Access Compliance Report

Public Rights-of-Way

(Curb Ramps)

Intersection ID: 44476	Main Street: LOYALIST_ST	Cross Street: WESTHOPE_ST	Location: E
ADA ID: 9429D04B934C	Ramp Type: BlendTrans1	Initial Pass/Fail: Fail	Overall Compliance: No
Severity Score: 8.75			
Codes/Mitigation Info/Possible Solution		Field Measurements/Component Compliance

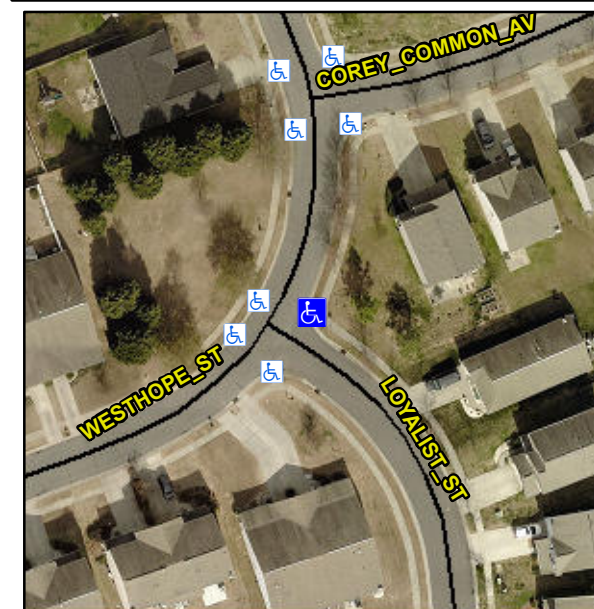
Not Found, R304.5.1

Compliance	Description	Data	Compliance	Description	Data
N/A	Ramp Length (in)	48.5	Yes	BlendTrans Slope (%)	1.6
No	Ramp Width (in)	47.5	Yes	BlendTrans XSlope (%)	1.7
N/A	Flare Type LT	N/A	N/A	Flare Type RT	N/A
N/A	Flare Slope LT (%)	N/A	N/A	Flare Slope RT (%)	N/A
N/A	Flare Traversable LT?	N/A	N/A	Flare Traversable RT?	N/A
N/A	Landing Length (in)	N/A	N/A	DWS Provided?	N/A
N/A	Landing Width (in)	N/A	N/A	DWS Contrast?	N/A
N/A	Landing Slope (%)	N/A	N/A	DWS Length (in)	N/A
N/A	Landing X Slope (%)	N/A	N/A	DWS Full Width?	N/A
N/A	Landing Curb? (Y/N)	N/A	N/A	DWS Offset (in)	N/A
N/A	Shared Landing?	N/A			
N/A	Gutter Ponding?	N/A	N/A	Gutter Slope (%)	N/A
N/A	Gutter Lip Ht (in)	N/A	N/A	Gutter X Slope (%)	N/A
N/A	Painted X Walk1?	No	N/A	Painted X Walk2?	No
	X Walk 1 Direction	To NW		X Walk 2 Direction	To SW
	X Walk 1 Width (in)	N/A		X Walk 2 Width (in)	N/A
	X Walk 1 Slope (%)	2.2		X Walk 2 Slope (%)	2.1
	X Walk 1 X Slope (%)	1.8		X Walk 2 X Slope (%)	0.2

N/A	Ramp inside XWalk1?	N/A	N/A	Ramp inside XWalk2?	N/A
	Road Slope (%)	1.6		Clear Space?	N/A
	Road X Slope (%)	3.8	N/A	Clear Space to XWalk (in)	N/A
N/A	Any Obstructions?	N/A	N/A	Storm Grate/Utility Hazard?	N/A
	Obstruction Type			Storm Grate/Utility Type	
		N/A			N/A
			Yes	Surface Condition? (G/P)	Good
			No	Curb Slope (%)	11.8

Remove & Replace Curb Ramp With Two New Directional Ramps or Equivalent.
